May 14, 1993  
LIC-93-0146

SUBJECT: Request for Additional Information Concerning the Fort Calhoun Station Spent Fuel Pool Rerack (TAC No. M85116)

OPPD Responses to April 8, 1993  
NRC Questions on the FCS Spent Fuel Pool Rerack

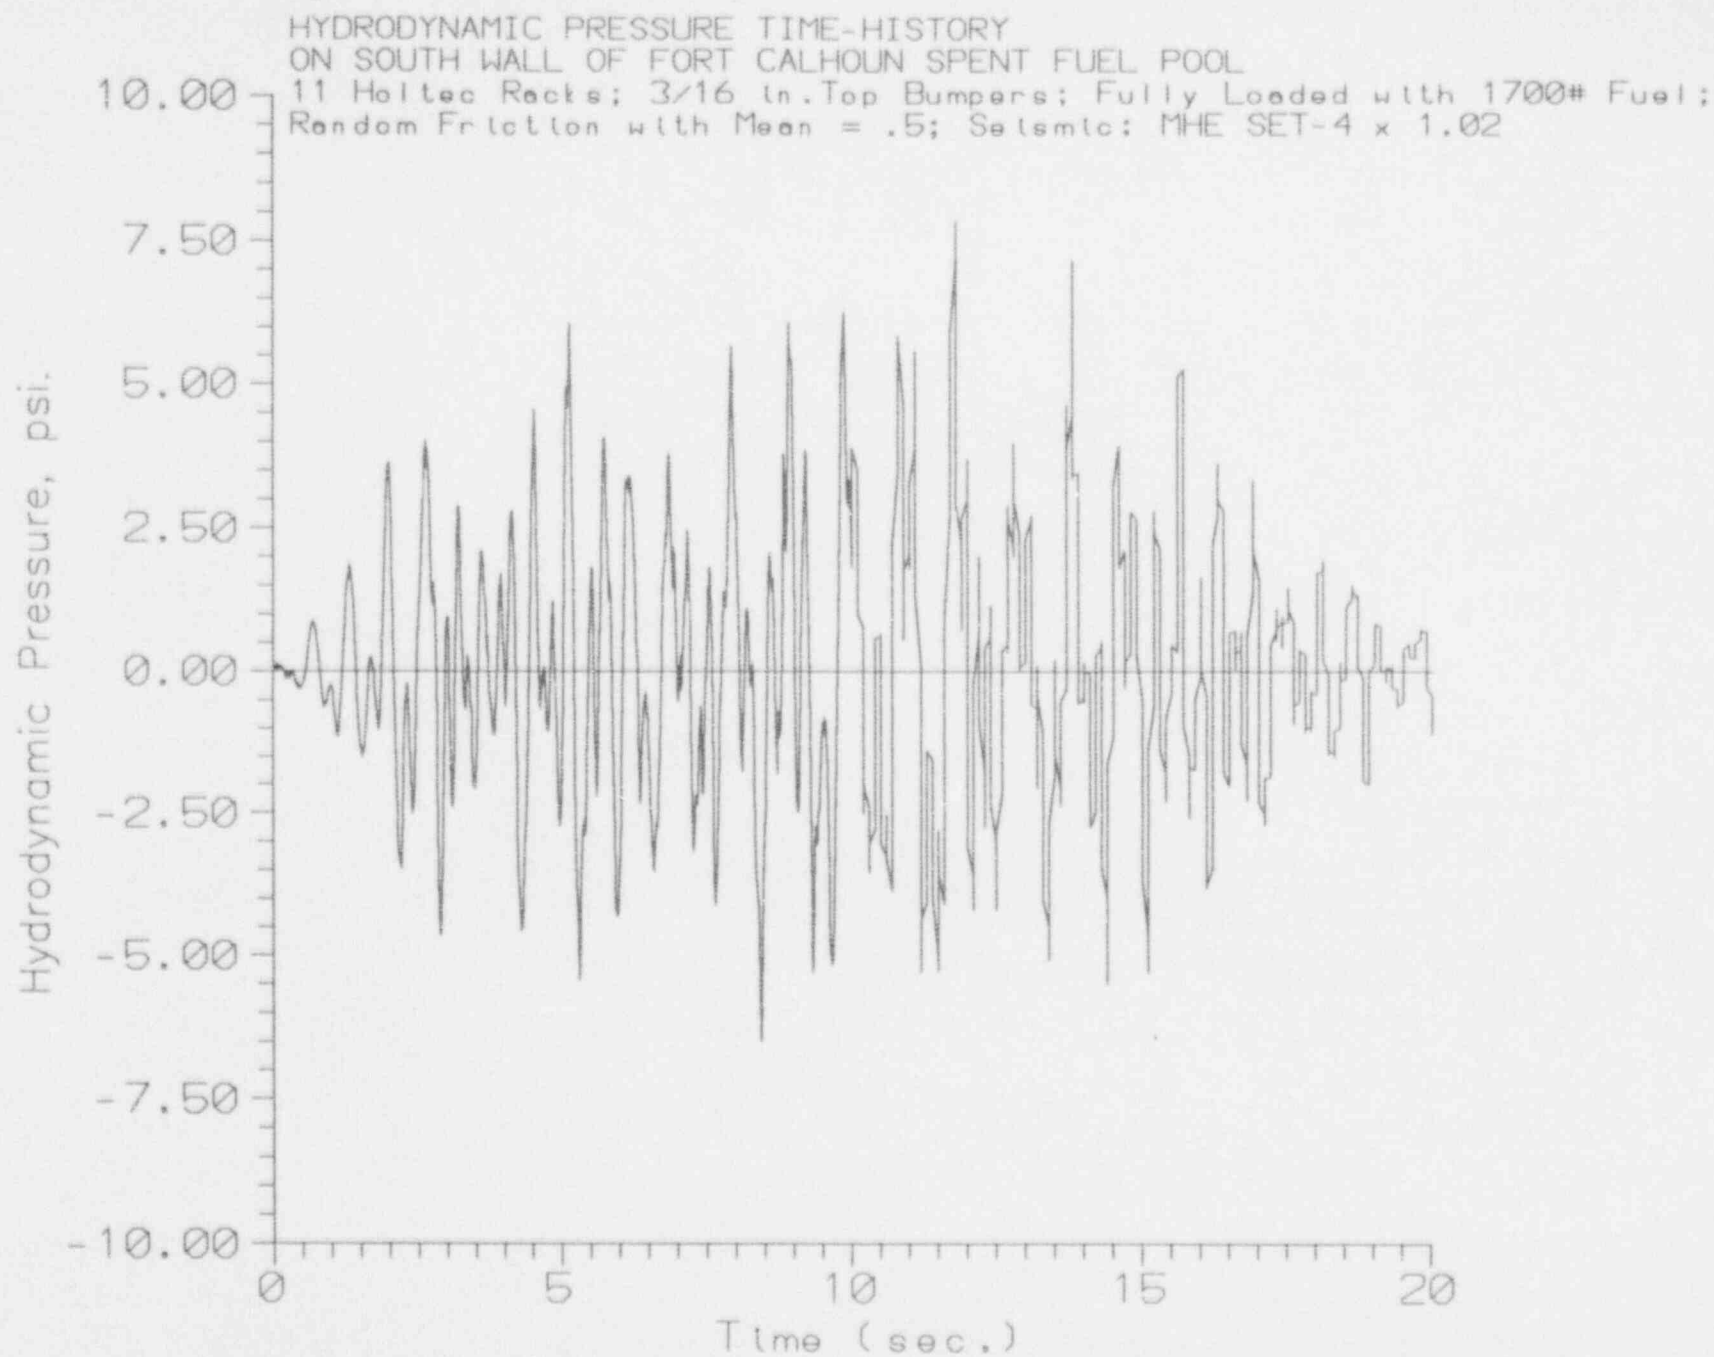
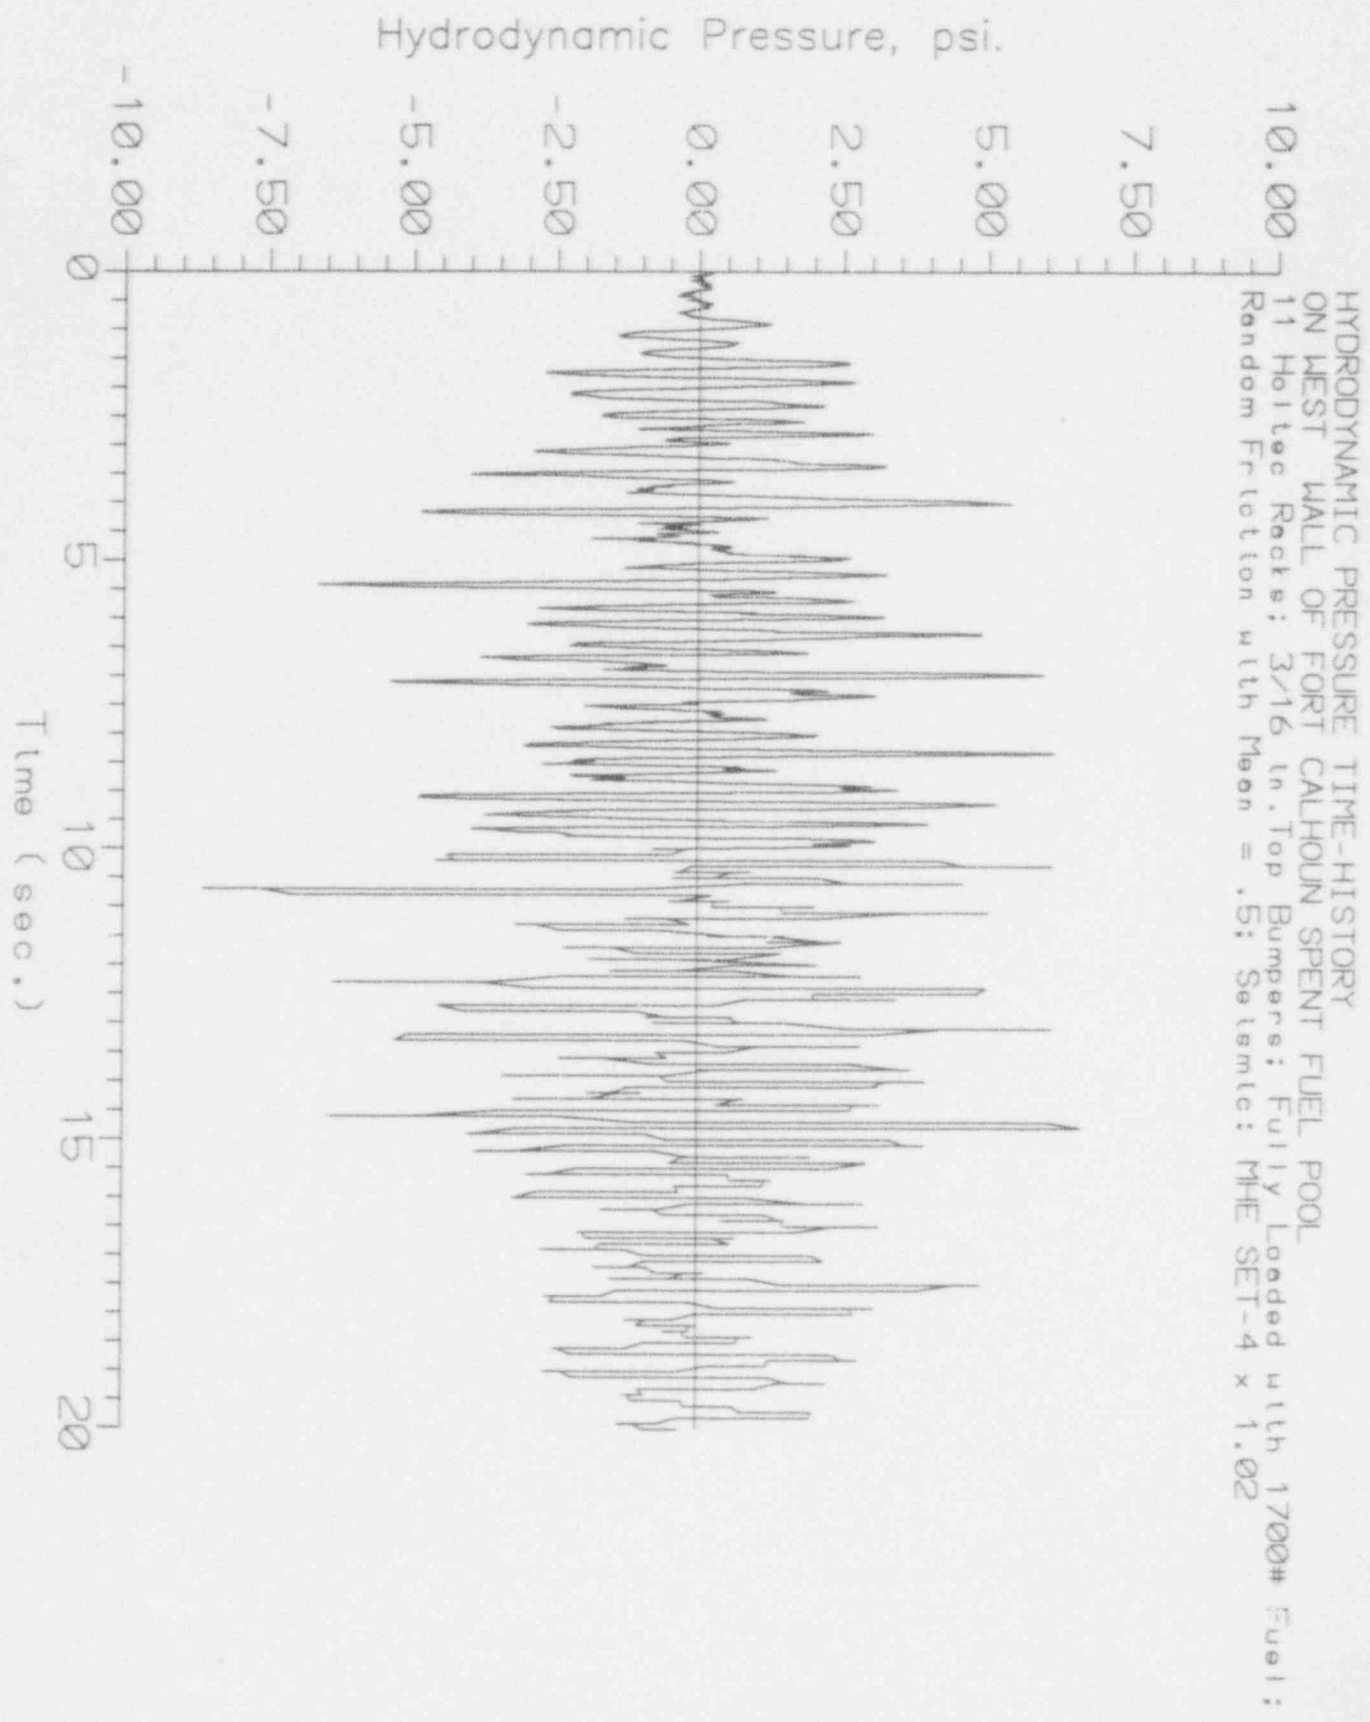
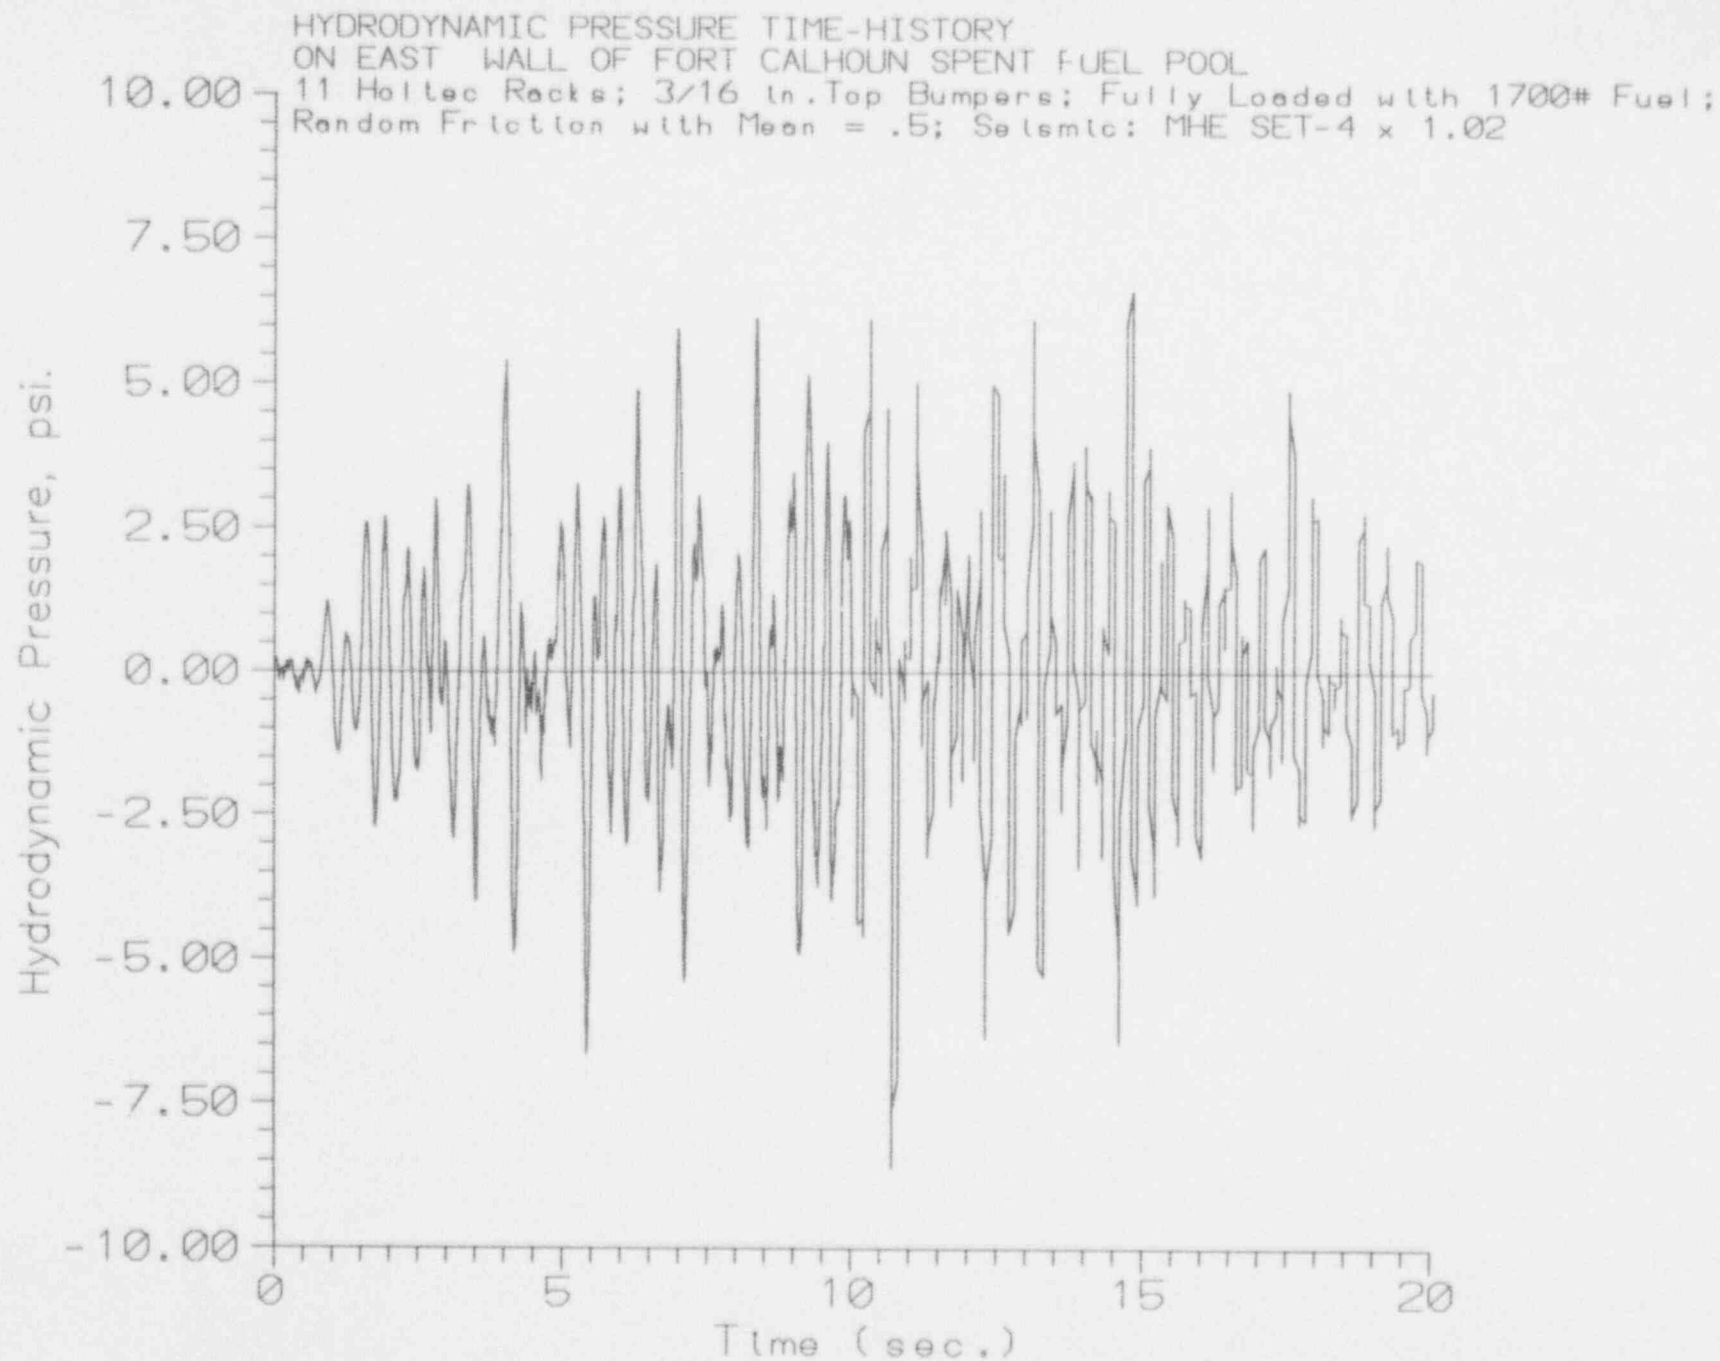
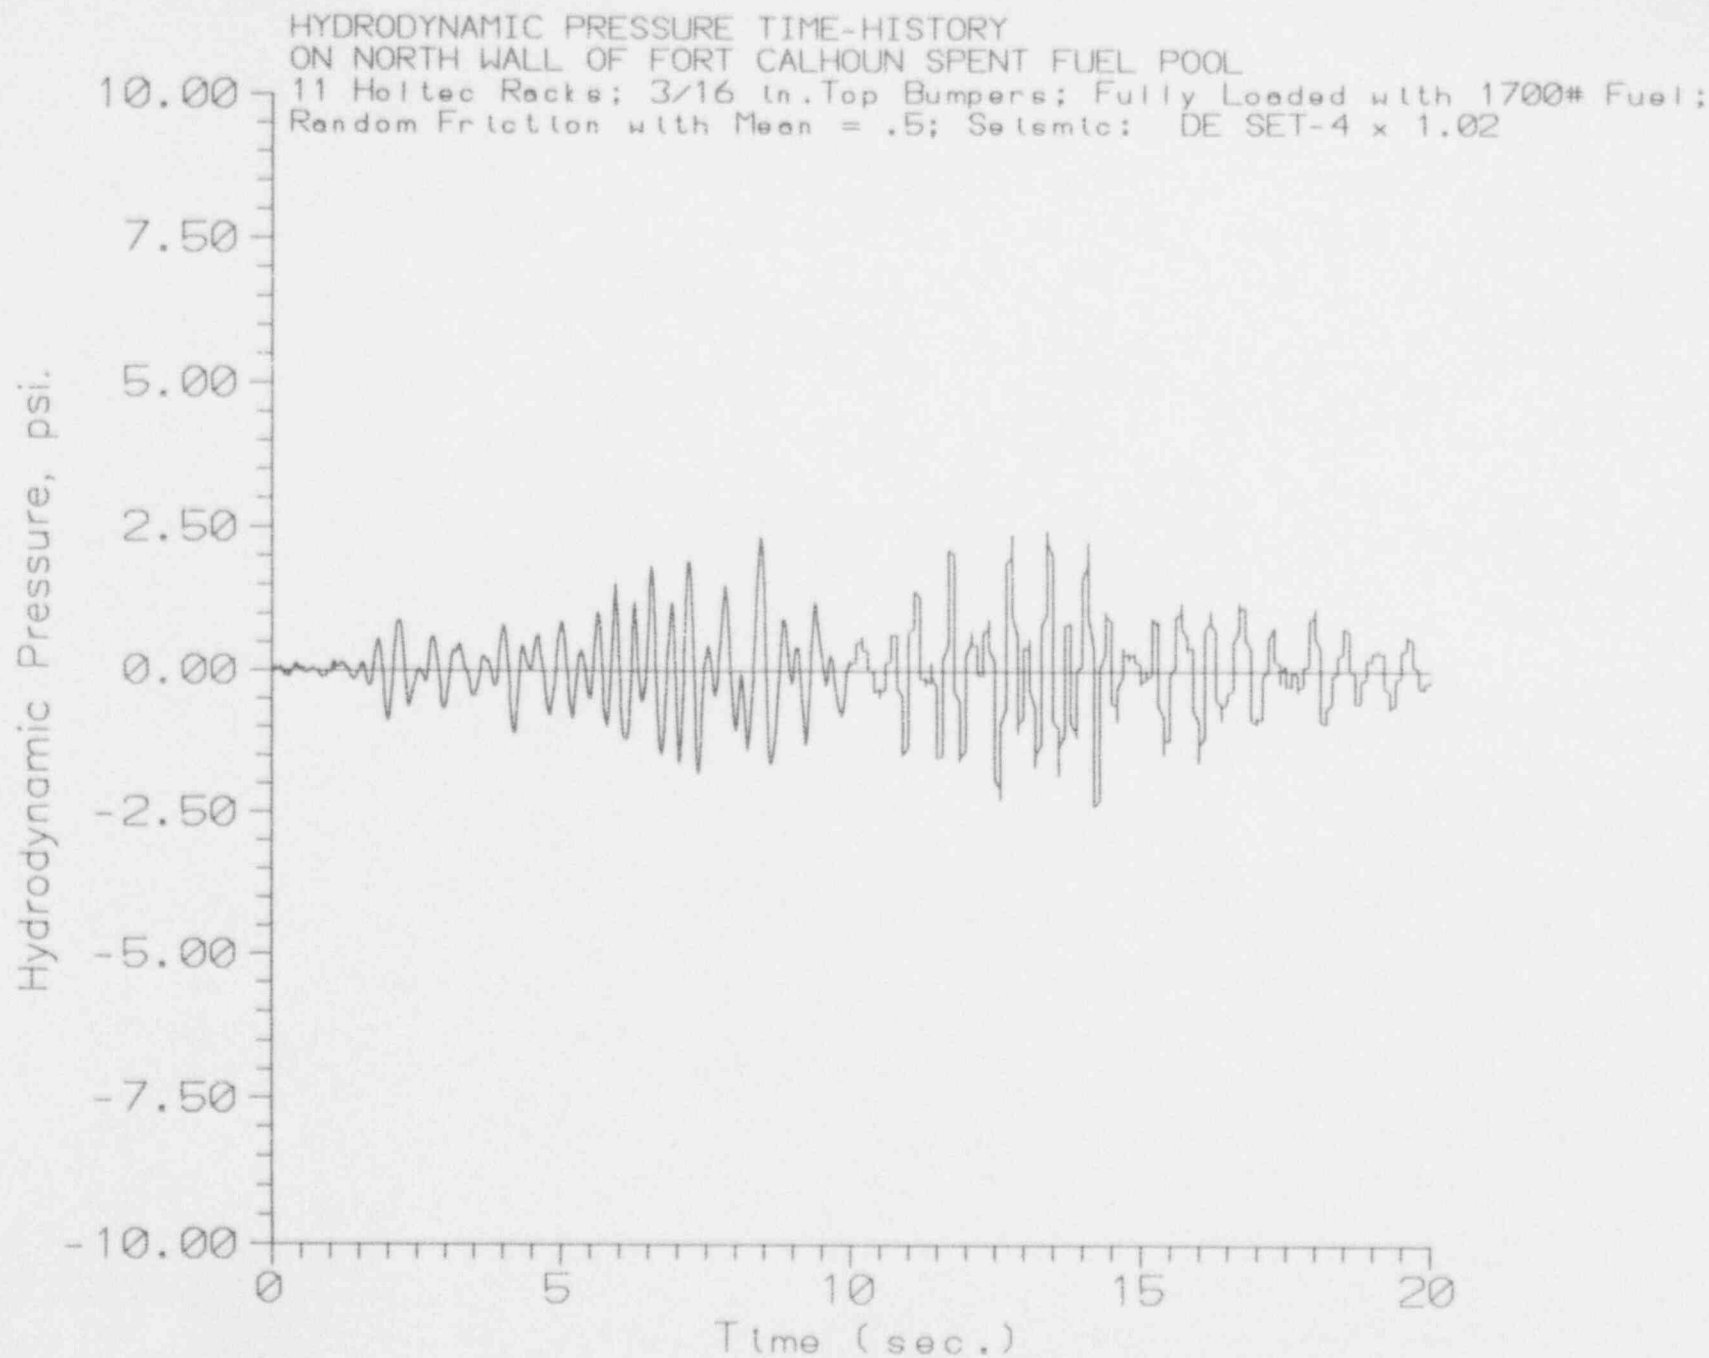
Provide the largest magnitude of the fluid pressure distribution along the height of the rack during the fluid and rack interactions for each case of the 3-D single and multi-rack analyses. Also, provide results of any existing experimental study that verifies the simulation of the fluid coupling utilized in the numerical analyses. [Note: OPPD is requested to provide results of experimental study in addition to the experimental study indicated in Reference Section of the submittal. The experimental study mentioned in Reference Section does not reflect realistic rack configuration, boundary conditions, rack and fluid interaction, and dynamic input loading conditions.]

The hydrodynamic pressure due to the relative movements between the assemblage of racks and the pool wall is available from the Whole Pool Multi-Rack (WPMR) analyses. The pressure distribution between the pool wall and the facing rack walls is utilized in pool structural evaluation and is therefore saved in the output files. The dynamic pressure time-histories on the walls for the WPMR analysis runs reported in the Reference 2 submittal are presented in attached Figures 2 through 9. Figure 10 shows the pool layout. Please note that the change in appearance of each plot beyond 10 seconds is due to the program not saving the time step to enough significant figures. The magnitudes are correct, however.
